# FRDM-KE02Z

# FRDM-KE02Z40M

# FRDM-KE04Z

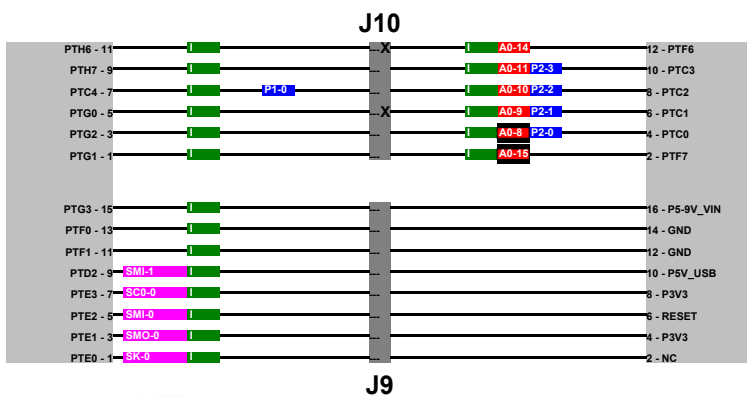
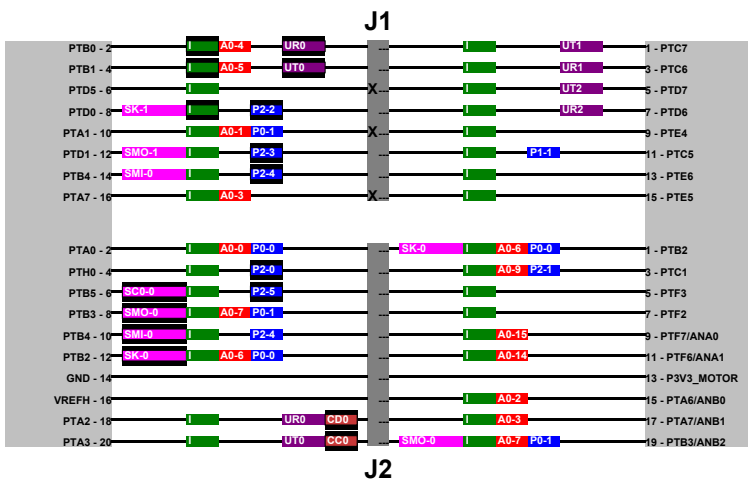
I on ports ??? (IRQ on PTA5)

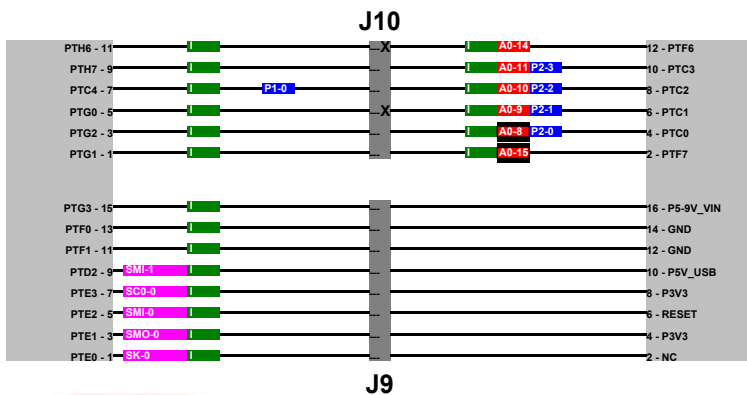
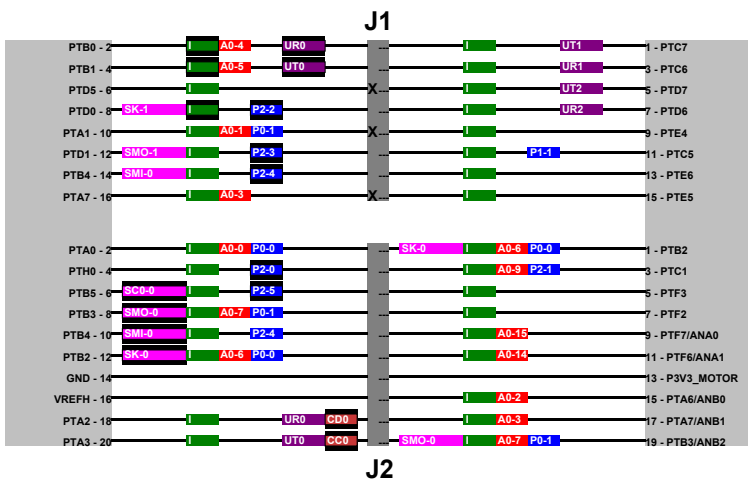
I on ports ??? (IRQ on PTA5)
